The Commission has issued the enclosed Amendments Nos. 137, 137, and 134 to Facility Operating Licenses Nos. DPR-38, DPR-47 and DPR-55 for the Oconee Nuclear Station, Units Nos. 1, 2 and 3. These amendments consist of changes to the Station's common Technical Specifications (TSs) in response to your request dated December 19, 1984, as supplemented on March 8, 1985.

These amendments revise the TSs to support the operation of Oconee Unit 2 at full rated power during the upcoming Cycle 8. The amendments change the following areas:

1. Rod Position Limits of TS 3.5.2; and
2. Power Imbalance Limits of TS 3.5.2.

SAFETY EVALUATION BY THE OFFICE OF NUCLEAR REACTOR REGULATION

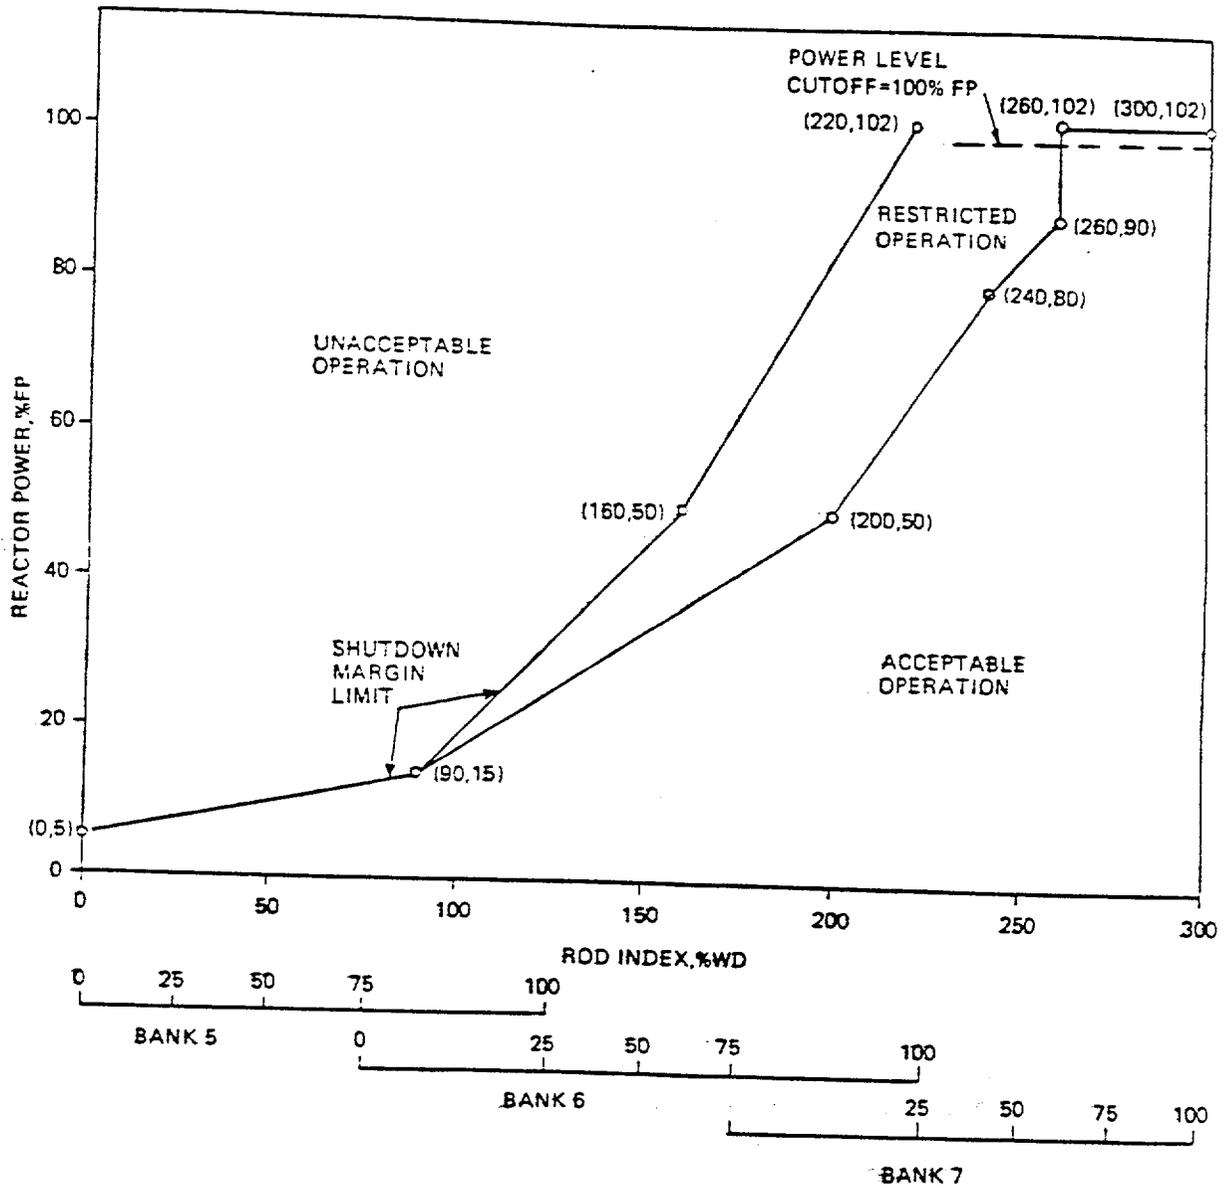
The specified flow rates of Figure 2.1-3B correspond to the expected minimum flow rates with four pumps, three pumps, and one pump in each loop, respectively.

The curve of Figure 2.1-1B is the most restrictive of all possible reactor coolant pump-maximum thermal power combinations shown in Figure 2.1-3B.

For each curve of Figure 2.1-3B, a pressure-temperature point above and to the left of the curve would result in a DNBR greater than the CHF correlation limit or a local quality at the point of minimum DNBR less than the CHF correlation quality limit for that particular reactor coolant pump situation. The curve of Figure 2.1-1B is the most restrictive of all possible reactor coolant pump-maximum thermal power combinations shown in Figure 2.1-3B.

Figure 3.5.2-2  
(1 of 1)

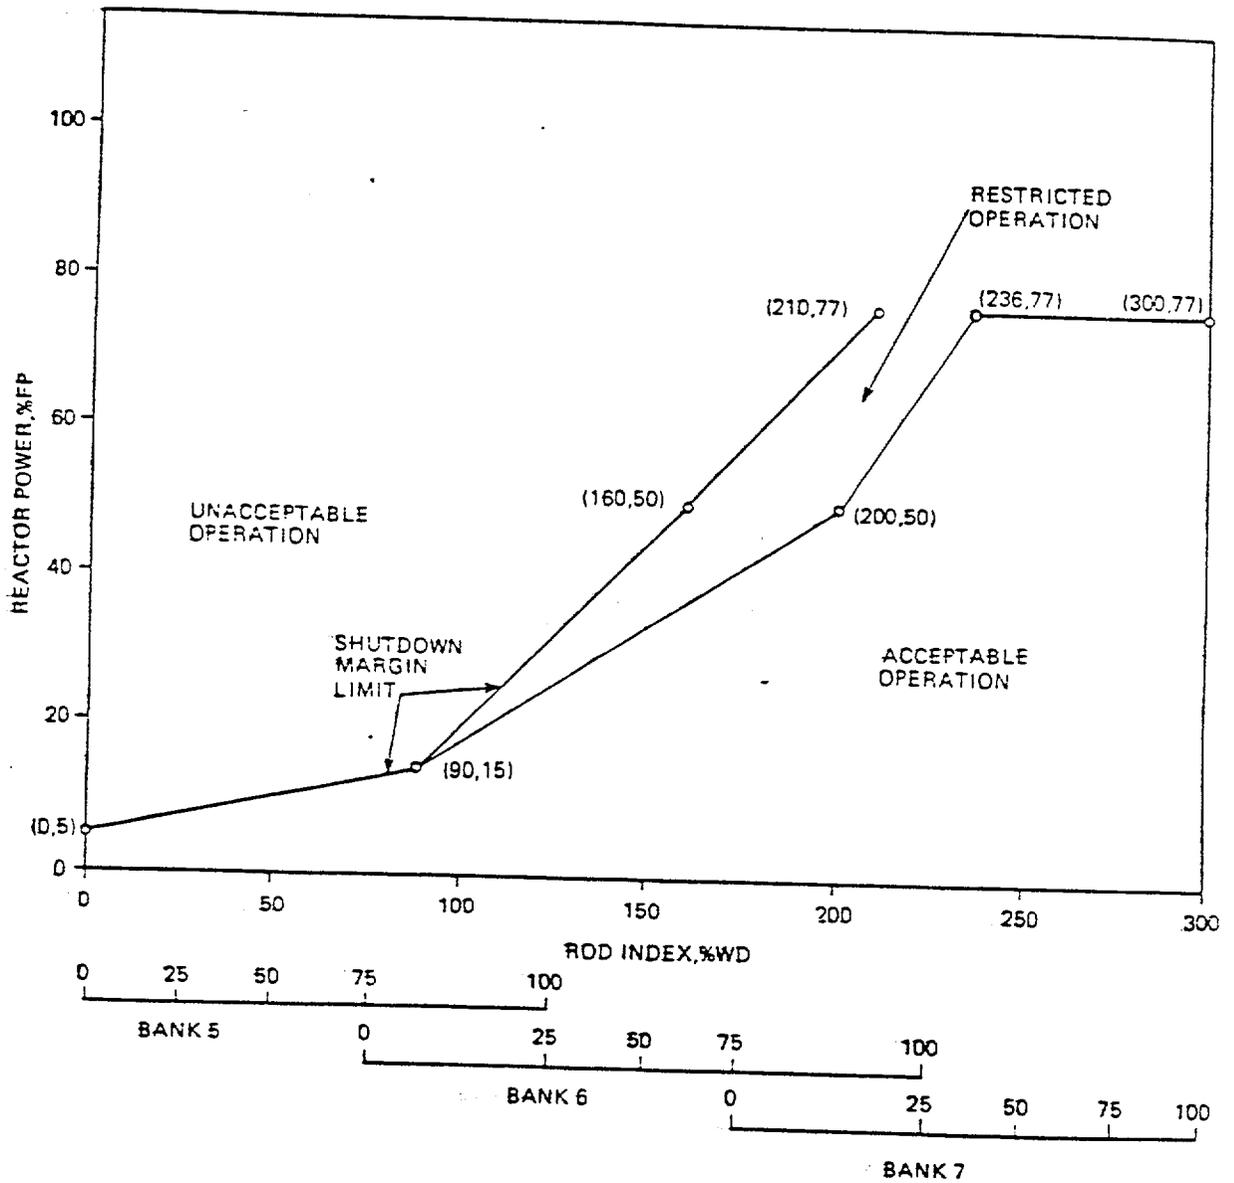
ROD POSITION LIMITS  
FOR FOUR PUMP OPERATION  
FROM 0 EFPD TO EOC  
UNIT 2.

Figure 3.5.2-5

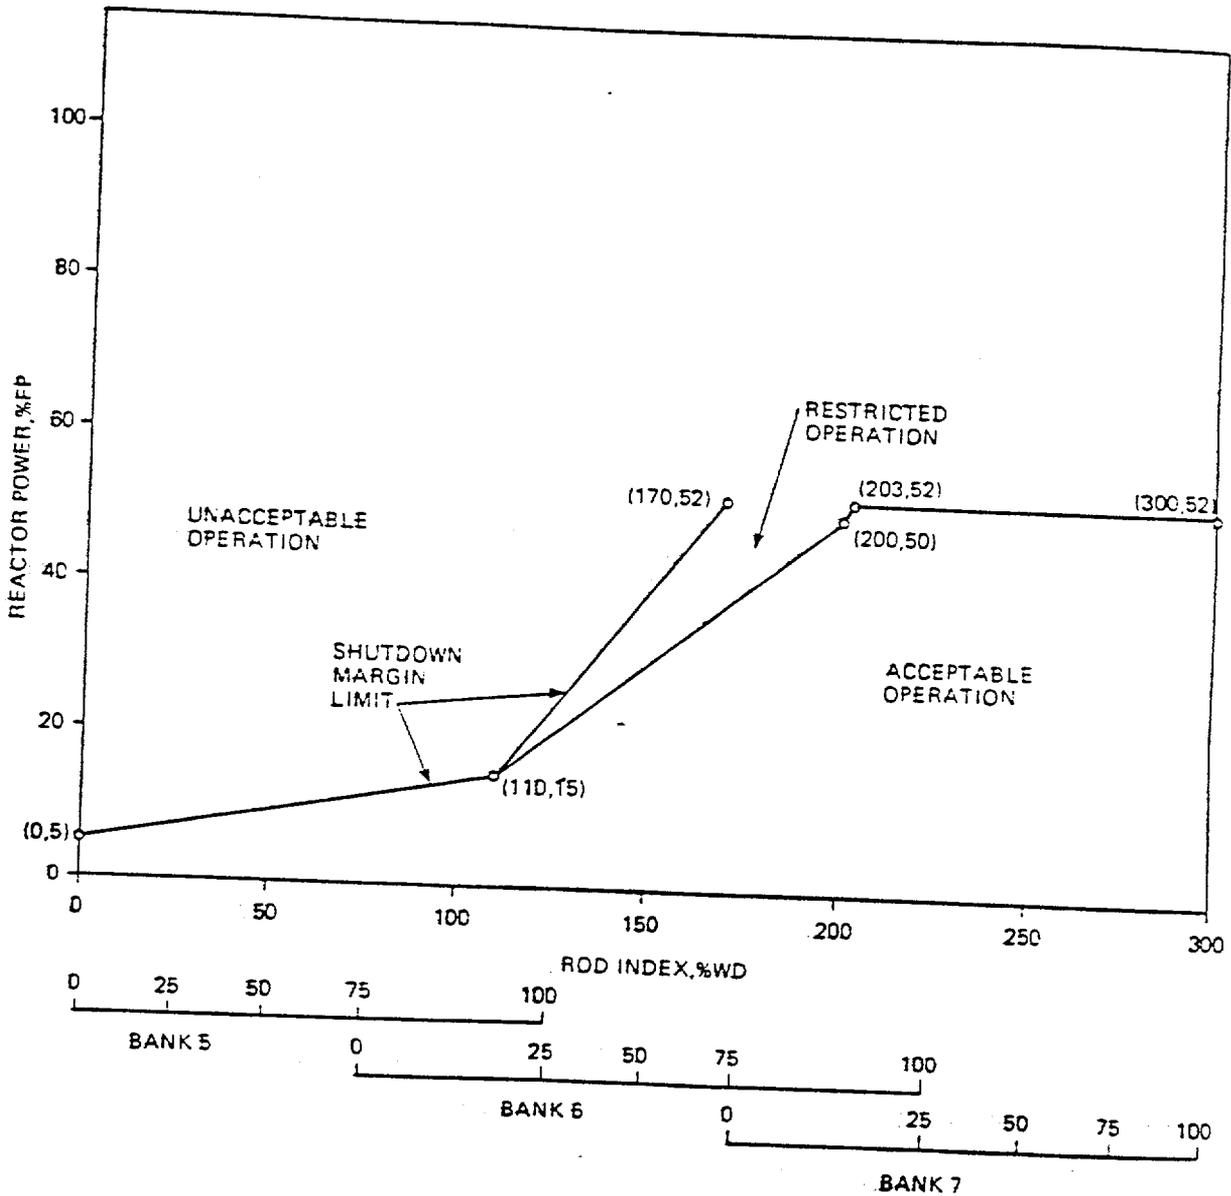
ROD POSITION LIMITS  
FOR THREE PUMP OPERATION  
FROM 0 EFPD TO EOC  
UNIT 2.
